# Access Compliance Report

## Public Rights-of-Way

Intersection ID: 10021	Main Street: S I-85 RA	Cross Street: TUCKASEEGEE_RD	Location: E
ADA ID: B8B705249D3E	Ramp Type: Perp	Initial Pass/Fail: Fail	Overall Compliance: No
		Severity Score: 35

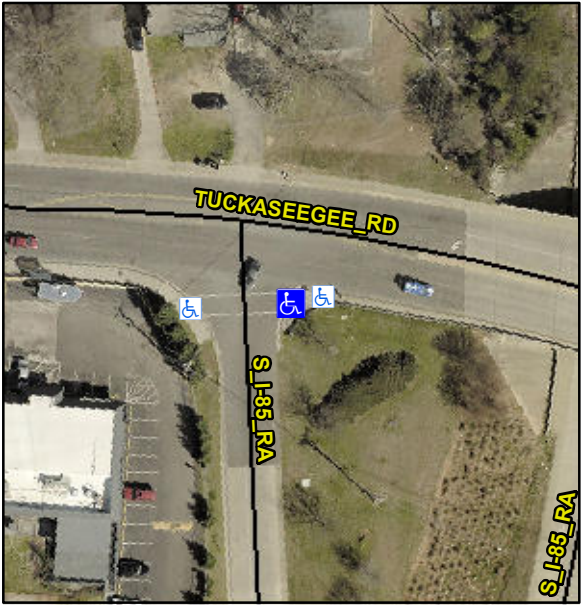
Codes/Mitigation Info/Possible Solution			Field Measurements/Component Compliance			
	Possible Solutions:		<b>Compliance</b>	<b>Description</b>	<b>Data</b>	<b>Compliance</b>
	<b>Remove &amp; Replace Entire Ramp.</b>		<b>No</b>	Ramp Length (in)	68.0	<b>No</b>
			<b>No</b>	Ramp Width (in)	45.0	<b>No</b>
			<b>N/A</b>	Flare Type LT	N/A	<b>N/A</b>
			<b>N/A</b>	Flare Slope LT (%)	N/A	<b>N/A</b>
			<b>N/A</b>	Flare Traversable LT?	N/A	<b>N/A</b>
			<b>N/A</b>	Landing Length (in)	N/A	<b>N/A</b>
			<b>N/A</b>	Landing Width (in)	N/A	<b>N/A</b>
			<b>N/A</b>	Landing Slope (%)	N/A	<b>N/A</b>
			<b>N/A</b>	Landing X Slope (%)	N/A	<b>N/A</b>
<p>Surveyor Notes:</p> <p><b>N/A</b></p> <p>PROW/ADA:</p> <p><b>Not Found, R304.5.1, R304.2.2, R304.5.3</b></p>			<b>N/A</b>	Flare Type RT	N/A	<b>N/A</b>
			<b>N/A</b>	Flare Slope RT (%)	N/A	<b>N/A</b>
			<b>N/A</b>	Flare Traversable RT?	N/A	<b>N/A</b>
			<b>N/A</b>	DWS Provided?	N/A	<b>N/A</b>

<b>N/A</b>	DWS Contrast?	N/A	<b>N/A</b>
			<b>N/A</b>	DWS Length (in)	N/A	<b>N/A</b>
			<b>N/A</b>	DWS Full Width?	N/A	<b>N/A</b>
			<b>N/A</b>	DWS Offset (in)	N/A	<b>N/A</b>
			<b>N/A</b>	Gutter Ponding?	N/A	<b>N/A</b>
			<b>N/A</b>	Gutter Lip Ht (in)	N/A	<b>N/A</b>
<p>Total Cost:</p> <p><b>\$ 1850.00</b></p>			<b>Yes</b>	Painted X Walk1?	N/A	<b>N/A</b>
			<b>To W</b>	X Walk 1 Direction	N/A	<b>N/A</b>
			<b>N/A</b>	X Walk 1 Width (in)	112.0	<b>N/A</b>
			<b>2.9</b>	X Walk 1 Slope (%)	N/A	<b>N/A</b>
			<b>1.2</b>	X Walk 1 X Slope (%)	N/A	<b>N/A</b>
			<b>N/A</b>	Ramp inside XWalk1?	Yes	<b>N/A</b>
			<b>N/A</b>	Road Slope (%)	N/A	<b>N/A</b>
			<b>N/A</b>	Road X Slope (%)	N/A	<b>N/A</b>
			<b>N/A</b>	Any Obstructions?	N/A	<b>N/A</b>
				Obstruction Type	N/A	<b>N/A</b>
			<b>N/A</b>	Clear Space?	N/A	<b>N/A</b>
			<b>N/A</b>	Clear Space to XWalk (in)	N/A	<b>N/A</b>
			<b>N/A</b>	Storm Grate/Utility Hazard?	N/A	<b>N/A</b>

Storm Grate/Utility Type	N/A	<b>N/A</b>
			<b>Yes</b>	Surface Condition? (G/P)	Good	<b>Good</b>
